1958 Corvette: Service Bulletin: Electric Windshield Wiper Information

Subject: Electric Windshield Wiper Information
Model and Year: 1958 Passenger Cars and Trucks
Source: Chevrolet Technical Service Bulletin
Bulletin No: DR #359
Section: I
Date: May 28, 1958

FIGURE #1.

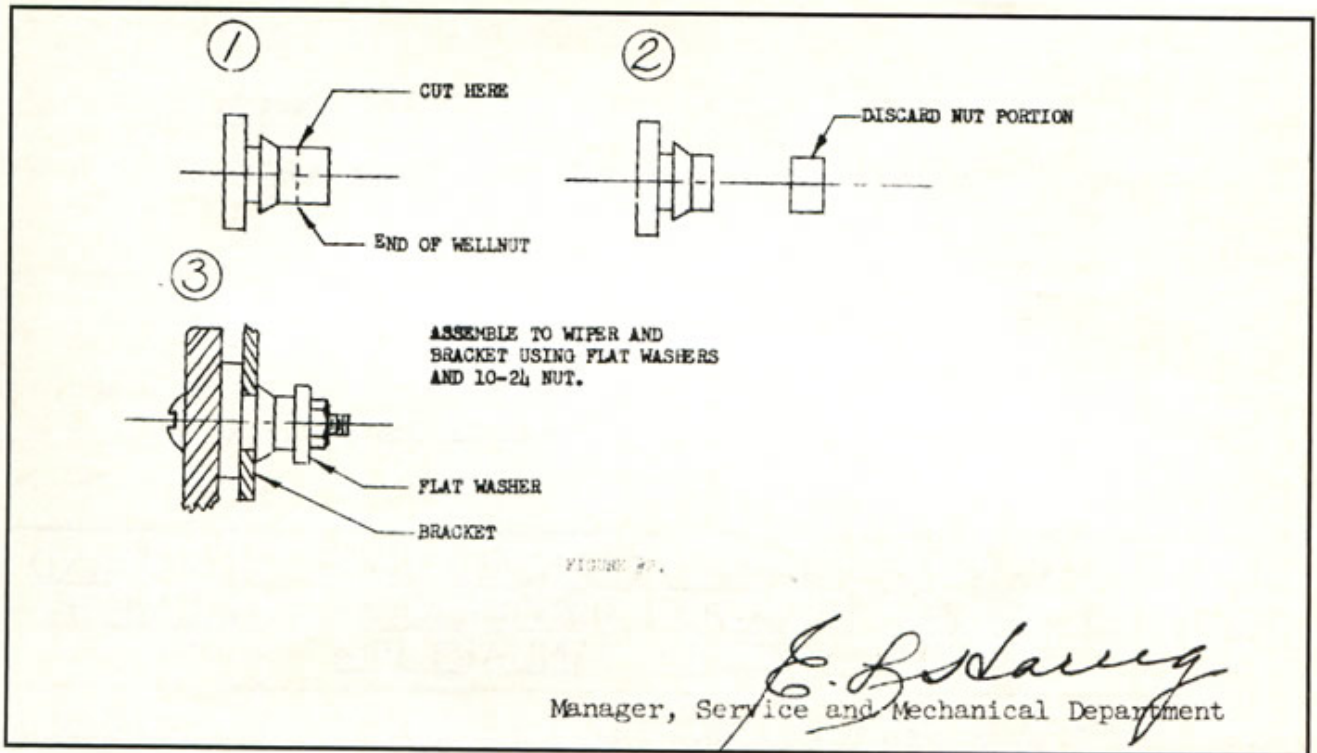
A parking spring has been released for production and service which enables the motor to shut off without depending on the resistance of the wiper blades. The spring is designed to clear the revolving arm in the "ON" position and stop the arm in the "PARK" position when switch is turned off. Figure #1 shows installation of parking spring.

A more durable replacement cam stop is available for service. Figure #1 shows details of installation. The existing tab must be bent flat before installation of the new stop.
